**Re: 1299 Boylston Street**

Reference: Traffic Study Peer Review **MEMO #5**  
Chapter 40B, 1299 Beacon Street  
Zoning District G-1.75, Precinct 10

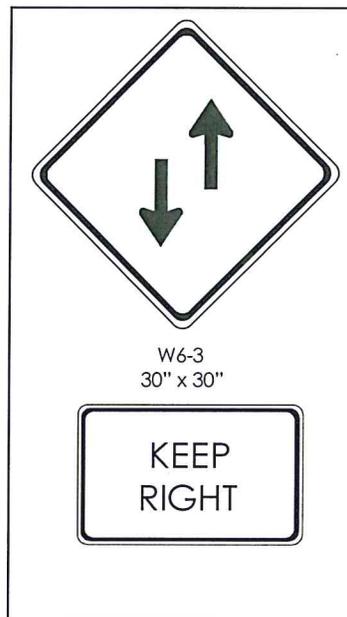
As you are aware, I have stressed the four design elements at the ramp intersections on the westerly end of the facility will result in less than safe operations. While any one of these physical elements can be rationally explained and accepted, it is the culmination of these four and interaction between them that is of paramount concern. Again, we believe a safe and efficient operation will maximize the use of the parking facility while a poorly designed and/or inefficient design may very well result in slower turn-over operation or even worse, some motorists choosing to park on public streets or in adjacent surface parking lots.

To reiterate, these four design elements include 1) the 23-foot wide access pavement width, 2) the 12 percent down slope, 3) the 23-foot pavement width through the 90-degree turn, and 4) the concrete wall restricting motorists stopping sight distance from the parking level through the 90-degree turn to the straight-away section of the ramp. This parking ramp access configuration comprised of both a vertical and horizontal curve with an extremely tight pavement width exacerbates the single concern of each individual element.

The 23-foot access pavement width is acceptable both in the Zoning-By-Law and as a practical matter above ground in a surface parking lot. However, when concrete walls are introduced underground, a sideline obstruction is introduced which tends to make some drivers nervous especially when combined with less than optimum lighting or a wet pavement surface. A typical new roadway would have two twelve-foot travel lanes with a two-foot offset or edge line on each side underground for a twenty-eight foot pavement width. The ramp itself proposes a 23-foot aisle width but ITE suggests the two-way aisle should be in the range of 26.5 to 29.5 feet. Although I would prefer a twenty-four foot minimum cross section width, I would understand the Board accepting the 23-foot Zoning-By-Law width within the straight-away section of the ramp.

The 12-degree down slope on the straight-away section is steep since ITE has indicated the straight-away access ramps typically range between eight and ten percent when the ramp does not serve adjacent parking. Obviously, an access aisle could range between zero and fifteen percent with the median at 7 ½ percent. Coincidentally, this is where the ITE feels the maximum

grade should be. My particular concern here is carrying the twelve percent down-slope through the narrow 90-degree turn.

More often than not, structured parking garages do have 90-degree turns or curves. However, The ITE Traffic Engineering Handbook suggest for turns within a ramp or at the end of a ramp of 90 degrees (such as here), the minimum radius to the inside edge of the inside lane is typically 15 feet increasing to between 30 and 45 feet of the outside lane, thus, yielding a curved ramp width of about 30 feet in this curve area. The proposal calls for only 23 feet from the straight-away section right through the 90-degree curve. Again my experience in the public sector required designing, operating, and maintaining parking structures and the proposed pavement width of only twenty-three feet through the curve when combined with the steep grade suggests this will be a problem.

The concrete walls inside ramp wall will constrict stopping sight distance to approximately 52 feet from the parking level toward the east. This SSD is only adequate for vehicle speeds up to about eleven miles per hour. Typically motorists will negotiate a ninety degree at about 18 miles per hour. Moreover, the required stopping sight distance of 52 feet is only for slopes of three percent or less and this slope of 12 percent would be safe for operating speeds less than eleven miles per hour.

Since motorists leaving the parking levels cannot see more than a few feet, the following signs should be installed for them to see prior to entering the ramp.

Moreover, since a double yellow center line tends to wear out quickly in a garage with sand falling off of cars and a ninety degree turn, a more permanent line material solution, rather than yellow paint, should be installed. Perhaps an epoxy-based paint applied annually could help motorist recognize the urgency of staying on their own side of the ramp.

I truly believe the 90-degree pavement section should be re-worked the **decrease** the slope in this short length and the pavement width should be **increased** from 23 feet to at least 28 feet through the 90-degree curve.
